Heritage, Design and Access Statement *SUPPLEMENTARY INFORMATION*

Change of Use of Offices to C3 Residential Serviced Apartments, The
Old Customs House, West Strand, Whitehaven – 22 May 2022

Commentary :

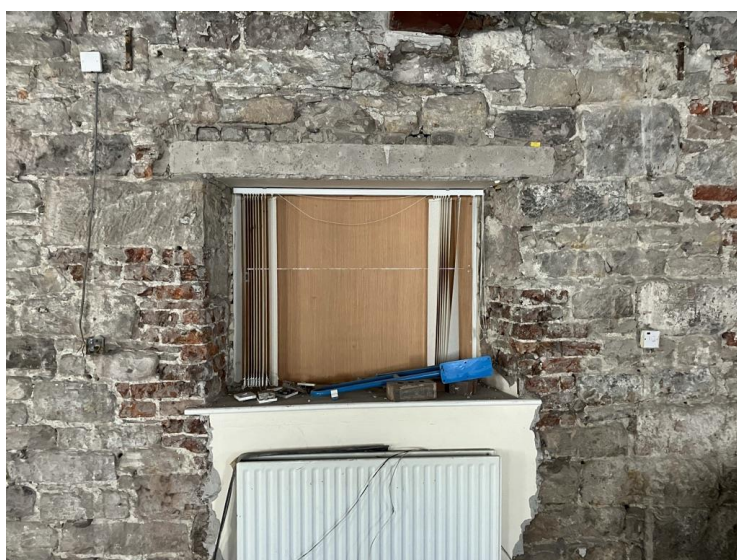
1.4 On the second floor an additional window opening is shown in the rear wall of the 'as proposed drawing', and two new staircases shown inserted through the ceilings. The impact on historic fabric and on the historic planform of the building however requires further explanation

Location of attic stairs to right hand gable of existing roof structure.

Location of attic stairs to left hand section of second floor – stairs fitted between truss and former 'party wall'

The photographs demonstrate that the works in creation of the attic floors do not impede on the existing roofing structure or layout. The trusses have previously been strengthened and altered over time. The works generally on this floor level allow the exposure of the existing roof structures to be read and are no longer obscured behind modern suspended ceilings.
